RESPONSE TO BRISBANE CITY COUNCIL FURTHER ADVICE – S.35 OF THE DA RULES

DEVELOPMENT PERMIT FOR MATERIAL CHANGE OF USE FOR A MULTIPLE DWELLING AND OVER LAND AT 68 BROWNING STREET, SOUTH BRISBANE (LOT 234 ON B137).

COUNCIL REFERENCE: A006908849

Further Advice Response

Figure 1: Proposed setback outcome - South-eastern boundary (Source: Plus Studio, 2026)

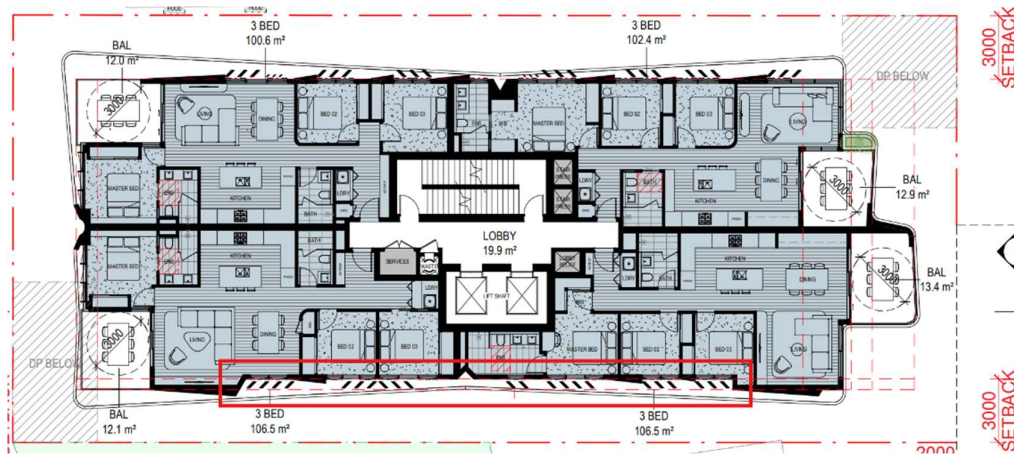
- a) *No habitable windows are within 3m of side boundaries;*
- b) *Ensure all habitable windows within the north-western façade within 5m from the side boundary incorporate privacy screening or opaque glazing up to 1.5m in height to address the requirements of the Multiple dwelling code and not prejudice future development and protect the amenity of the existing use/s on the adjoining site;*

- As shown in **Figure 1** below, the tower setback to habitable rooms has been increased to achieve a minimum 3 metre setback to the south-eastern boundary (across Levels 1 – 9) in response to **Item 2(a)** of Council's Further Advice. The balance elements of that façade comprise blank walls. Refer to **Figure 1** below.

Figure 3: Revised ground level car parking arrangement (Source: Plus Studio, 2026)

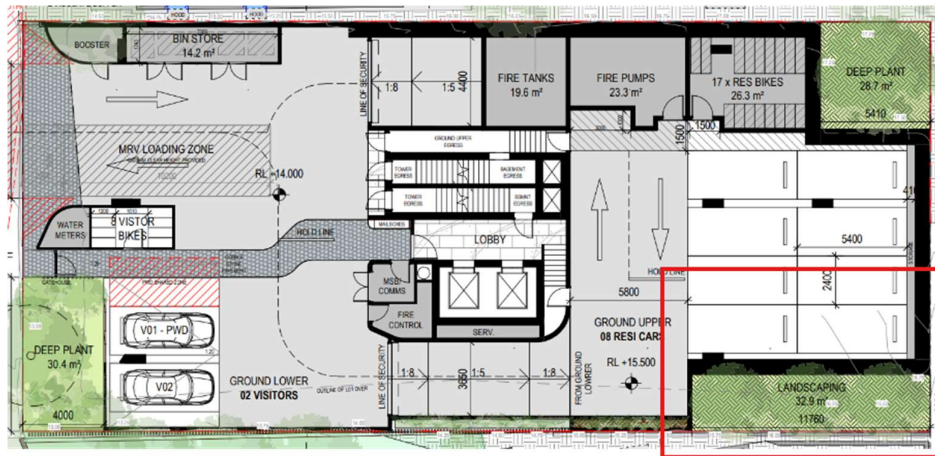
- d) *Increase the extent of boundary landscaping and reduce the length of the built to boundary wall adjoining the Local Heritage Place on the southern elevation in accordance with PO28 of the Multiple dwelling code. This may be achieved through a reduction of residential car parking spaces at ground level; and*

- Through the changes to the ground level car parking configuration, additional landscaping has been incorporated along the south-eastern boundary of the site to improve the interface between the proposed development and the Local Heritage Place. The revised landscape outcome is presented in **Figure 5** below. The proposed landscaping area is of a sufficient size and depth to accommodate a combination of layered subtropical plantings including ground covers, small shrubs, canopy trees and climbing plants that will be planted at an established size.
